Sheringham Shoal and Dudgeon Offshore Wind Farm Extension Projects

The Applicant's comments on Natural England's Deadline 2 Submission

Document Reference: 16.6

Response to query over reptile 'translocation'

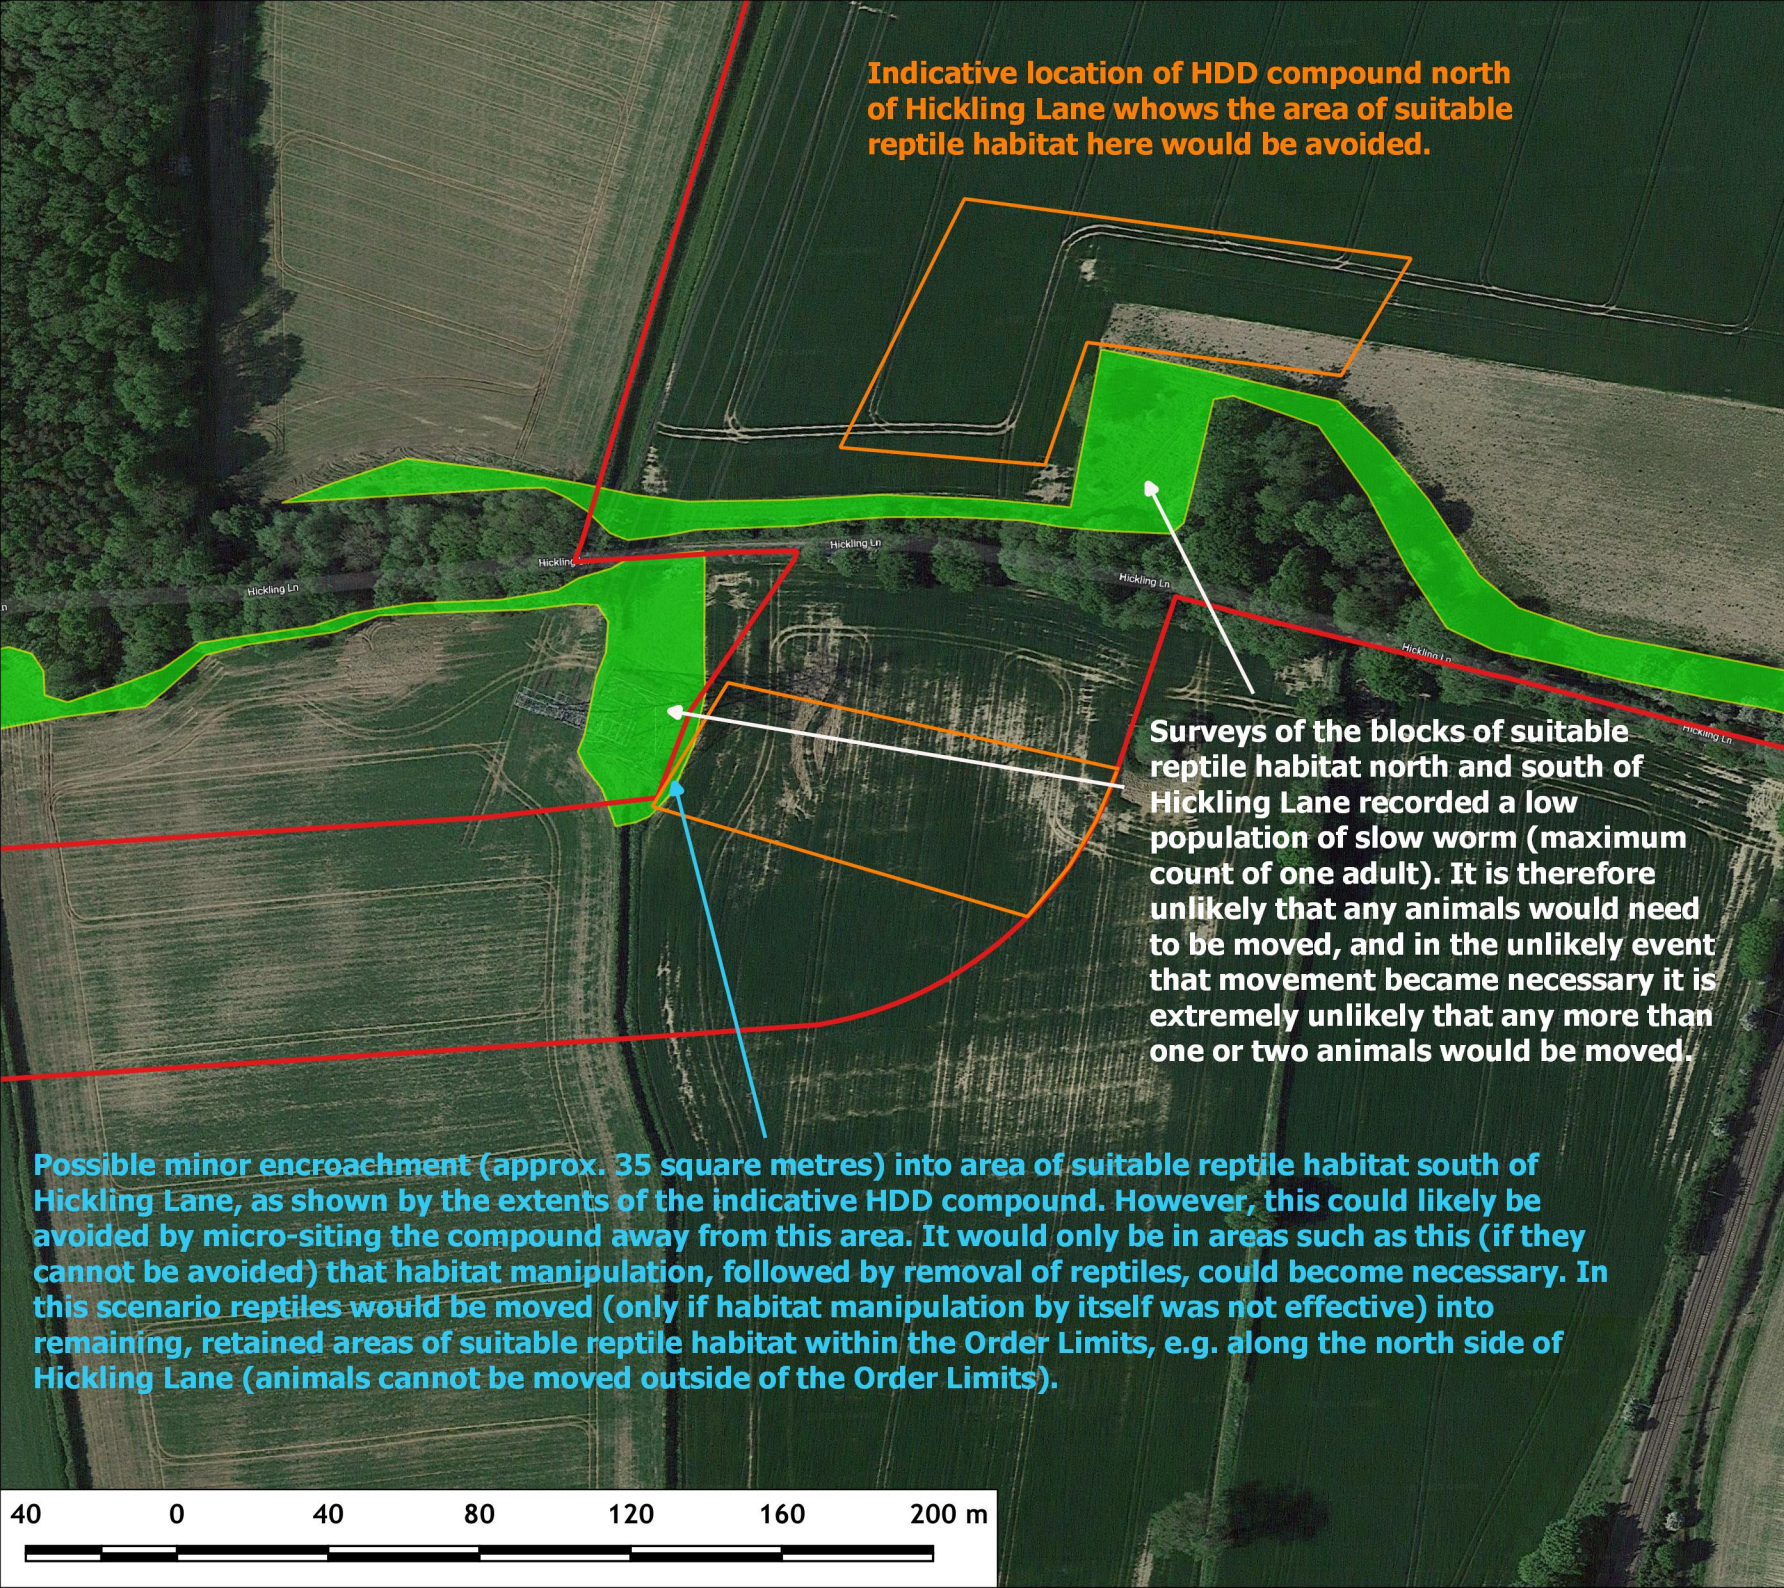
2.3.6	18	55	22	<p>Natural England welcomes the Applicant's commitment to manage for reptiles prior to construction and the undertaking of a phased approach. We also welcome the Applicant's commitment to undertaking pre-construction reptile surveys to inform an update to the measures which should be included within an OLEM at the consenting phase to ensure that measures can be implemented to avoid killing/injury of reptiles during construction.</p> <p>If additional habitats are found during the walkover survey to be suitable for reptiles, and for where pre- construction reptile surveys find additional populations of reptiles, Natural England advises including a commitment to consult with the relevant planning authority on the need for additional measures to be implemented beyond those set out within the EMP/OLEM. There would also need to be a requirement to update the EMP/OLEM prior to</p>	<p>Outline Ecological Management Plan (Revision C) [document reference 9.19, Appendix 1] details that pre-construction reptile surveys would only be completed if new areas of suitable reptile habitat are found during the pre-construction Extended UK Habitat classification surveys, or if new information on reptile distribution comes to light (such as NBIS records).</p> <p>In the event that new sites are surveyed for reptiles and these surveys confirm the presence of reptiles, this information will be submitted to the relevant planning authority, along with a proposed mitigation approach for the site/s, as part of the submission of results of pre-construction surveys.</p> <p>Requirement 13 (Ecological management plan) of the draft DCO (Revision F) [document reference 3.1] states that:</p> <p>No phase of the onshore works may commence until a written ecological management plan (which accords with the outline ecological management plan and the relevant recommendations of appropriate British Standards or Industry Guidance) for that phase reflecting the survey results and ecological mitigation, enhancement and biodiversity net gain measures included in the environmental statement has been submitted to and approved by the relevant planning authority in consultation with the relevant statutory nature</p>

Indicative location of HDD compound north of Hickling Lane shows the area of suitable reptile habitat here would be avoided.

Surveys of the blocks of suitable reptile habitat north and south of Hickling Lane recorded a low population of slow worm (maximum count of one adult). It is therefore unlikely that any animals would need to be moved, and in the unlikely event that movement became necessary it is extremely unlikely that any more than one or two animals would be moved.
